Punch List for South Texas Project Units 3 & 4
Sections 3.7 & 3.8

South Texas Project Units 3 & 4

Clarifications from NRC

NRC Audit of South Texas Project Units 3 & 4
May 23 - 27, 2011

Issue 8: [Received 04/04/2011] (Audit Action Item 3.7-33 and 35) Stability Analysis Procedure

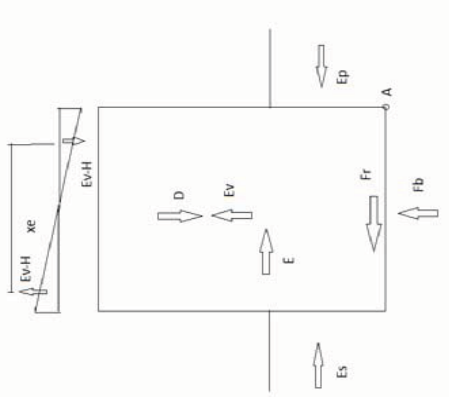
A brief presentation of the stability analysis procedure was made by the applicant during the March 14, 2011 audit. The presentation included a rigid body diagram showing the forces acting on the structure for stability calculations. The applicant indicated that the total seismic demand is calculated by summing all the inertia forces and moments acting on the structure. These inertia forces are calculated by multiplying the mass of each node by the absolute value of the maximum acceleration response at that node obtained from the SSI analysis.

The calculation of the seismic overturning moment is based on the horizontal seismic load E and vertical seismic load E_v about tipping point A , as shown in the figure below. The moment due to horizontal earthquake does not include E_v-H (vertical force due to horizontal input) which also produces overturning moment about A . The applicant is requested to provide justification for not including the vertical component of response due to horizontal seismic input in calculating the foundation overturning moment.

- E – Horizontal seismic force
- E_v – Vertical seismic force
- E_s – Soil active force
- E_p – Soil passive resistance
- D – 0.9 of dead load
- F_b – Buoyancy force
- F_r – Frictional resistance
